Planning, Land Use and Mobility Committee
Case Report / Rev 7.16.20; Rev 8.6.20
DIR-2019-4861-DRB-SPP-MSP / Single Family Residence
22552 W. Uhea Road
Woodland Hills, CA 91364

Project Description: New Single Family Residence
Applicant: Javanshir Rad t: 213.361.6555; e: danny@radtronics.com;
Representative: Behrouz Bozorgnia/Mobbil Inc; t: 310.562.6427; e: bbozorgnia@mobbil.com
LA City Planner: Valentina Knox-Jones: 818.374.5038; valentina.knox.jones@lacity.org
Case Leader: Lauren Coffman / PLUM Chair / l.coffman@whcouncil.org
PLUM Meeting: January 9, 2020 / First Presentation
July 16, 2020 / Second review by PLUM Committee only
August 6, 2020 / Third Review

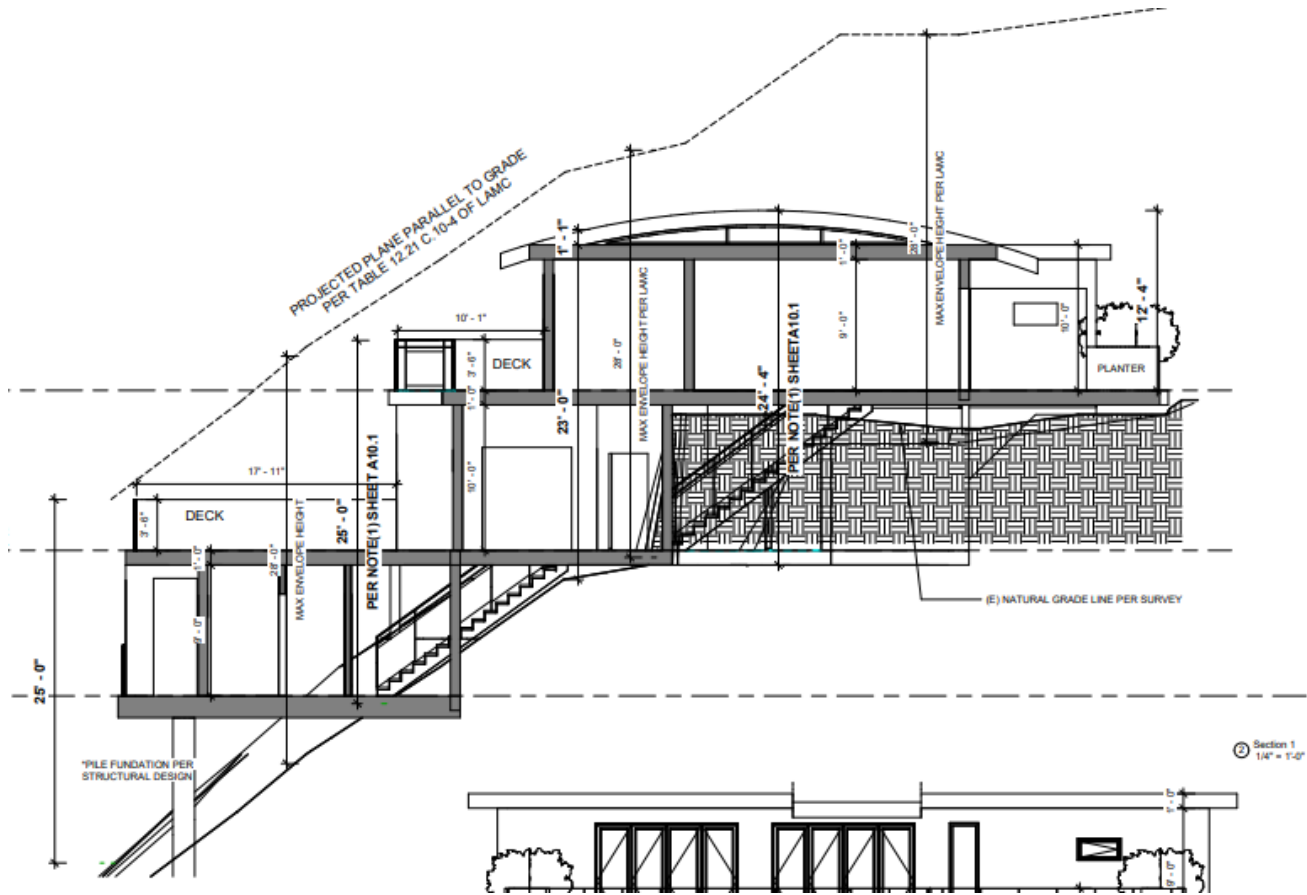
The project requires 1,100.1 cubic yards of cut and 9.08 cubic yards of fill for a total export of 1,091.03 cubic yards for grading. **Maximum allowable, as per the Hillside Ordinance is 1,000 cubic yards. Lots fronting on Substandard streets are limited to 750 cubic yards of cumulative grading.** The project proposes to work with the average natural slope of 35%. There are no trees proposed to be cut down.

1 North
1/4" = 1'-0"

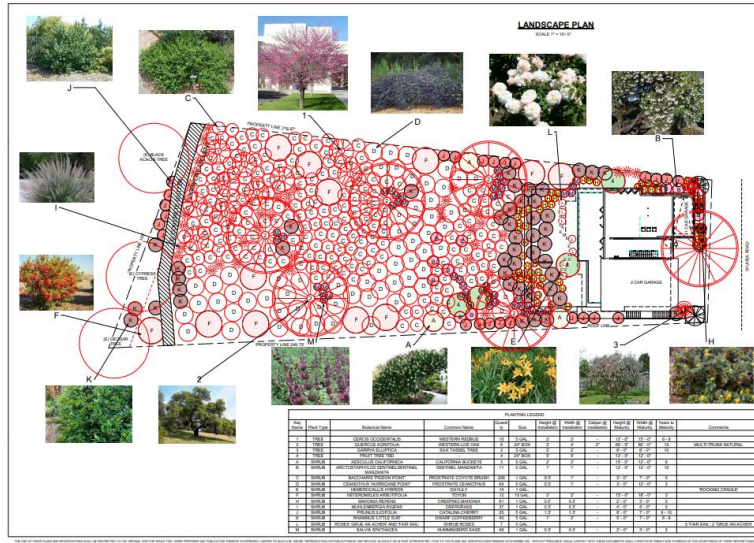
4. The exterior white stucco color will not comply with Santa Monica Mountains Color Wheel.

8.6.20: See new colored elevations. Colors comply with color wheel suggested by Santa Monica Mountains Suggested Color Wheel.

Original Planting Plan

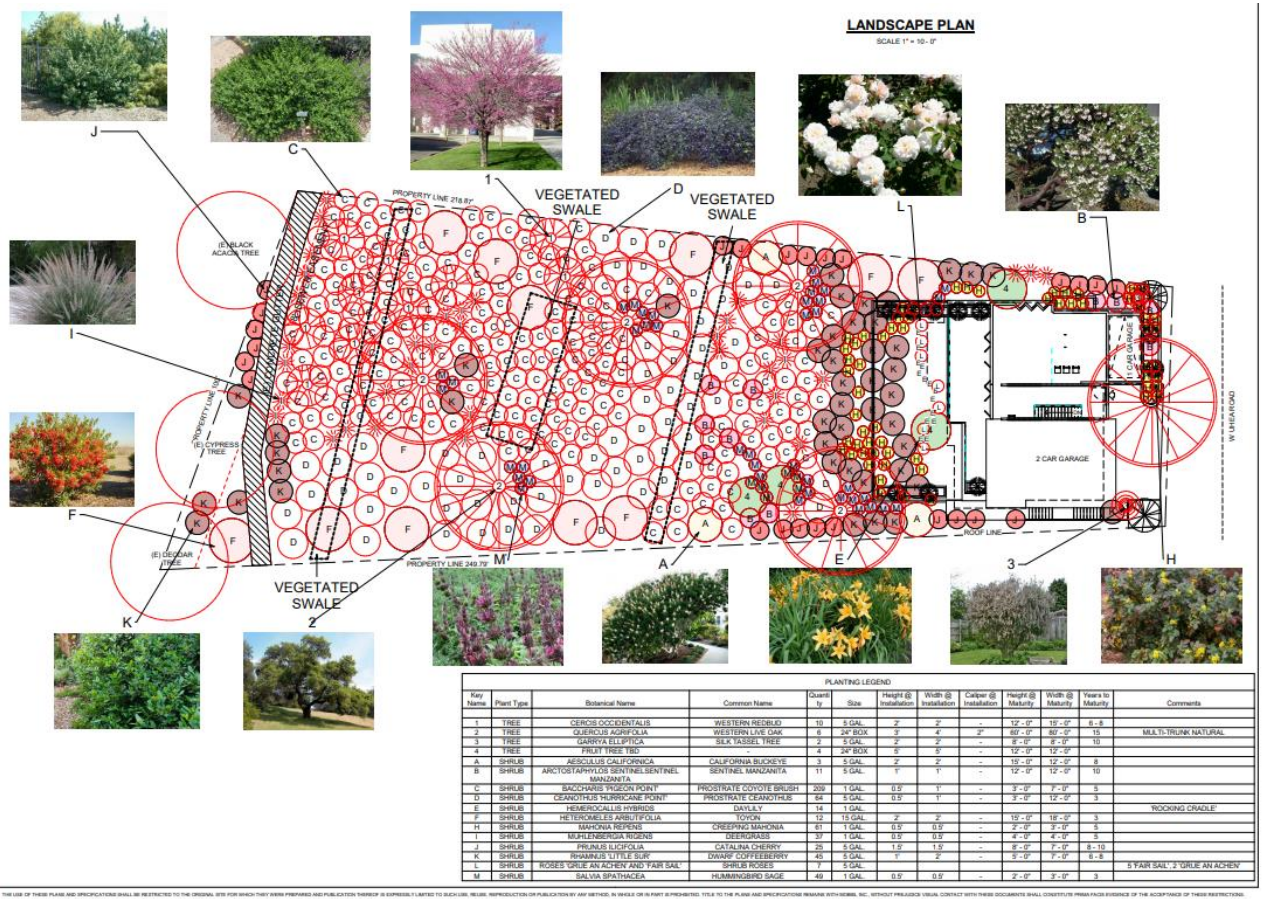
5. Drainage not addressed: Where is all the roof drainage going? What is the project system for Storm water Infiltration? Applicant should consider terracing the site to slow down rain water flow to neighborhood below. See Page 10 this report / Revised Planting Plan. As per Guidelines For Storm Water Infiltration, it is very possible that planter boxes will not be allowed on elevated platforms, decks or porches. Consult the building code officials.

8.6.20 / Revised Planting Plan with Vegetated Swales In response to PLUM's request for better management of storm water site drainage site terracing and more controlled storm water drainage, the applicant has introduced vegetated swales to slow the storm water flow, as demonstrated on revised sheet A11 / Landscape Plan. I think these swales need to be wider, more like terraces, to be effective. The Natural Drainage Pattern existing allows only for sheet flow, which creates water flow too fast to irrigate new planting.

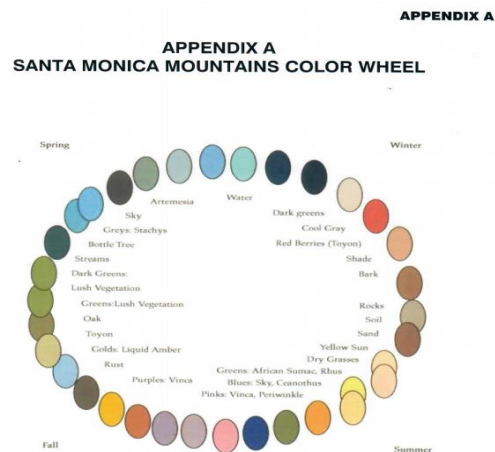
2. Building envelope height still does not conform. Maximum Envelope Height “ Envelope height (otherwise known as vertical height or “plumb line” height) shall be the vertical distance from the Grade of the site to a projected plane at the roof structure or parapet wall located directly above and parallel to the Grade. Measurement of the envelope height shall originate at the lowest Grade within 5 horizontal feet of the exterior walls of a Building or Structure.” 12.21.C.10.(d)(1) of the LAMC

8.6.20: On sheet A10 and A10.1, the applicant demonstrates the maximum envelope height correctly: 28’ is allowed for flat roof structures, and the project has an envelope height of 25. The maximum envelope height is taken from the lowest grade, which is at the base of the caissons, where they enter the earth.
